Electrical harness changes

Program changes -

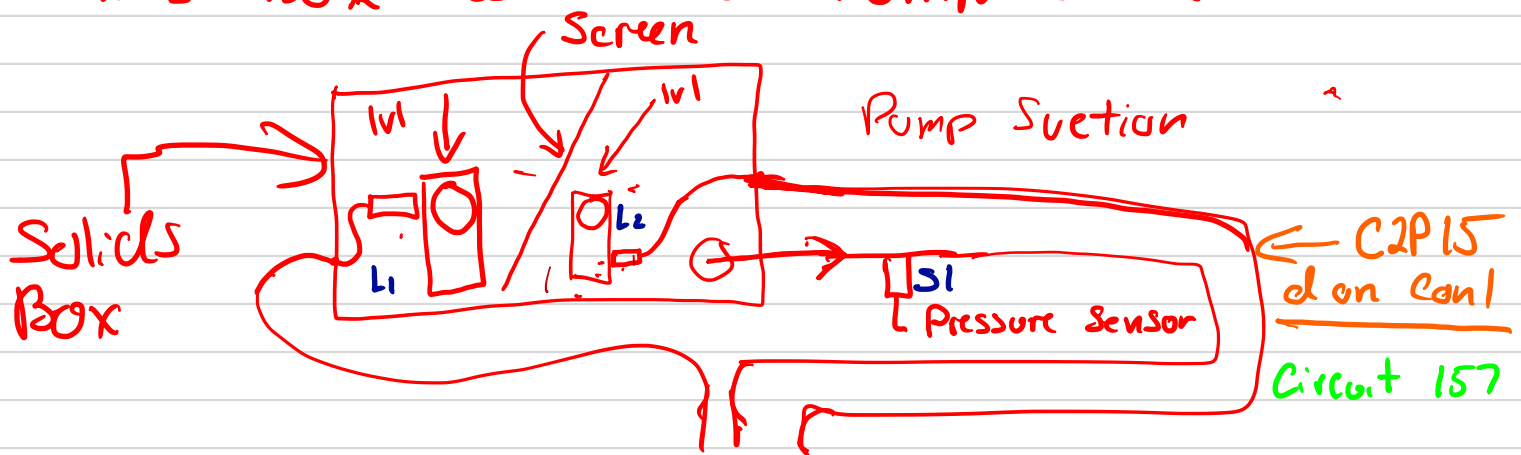
- ↳ Add additional sensor for aux washdown pump
- ↳ add level sensor in Solids Box

Unloader - AUX Washdown Pump

Solids box Level Sensor Pump Control

The System will monitor both level sensors and the pressure transducer

If L₁ is high and L₂ is Low for some time then Screen is Blocked

If L₂ is high and SI PSI is Low for some time pump is faulted
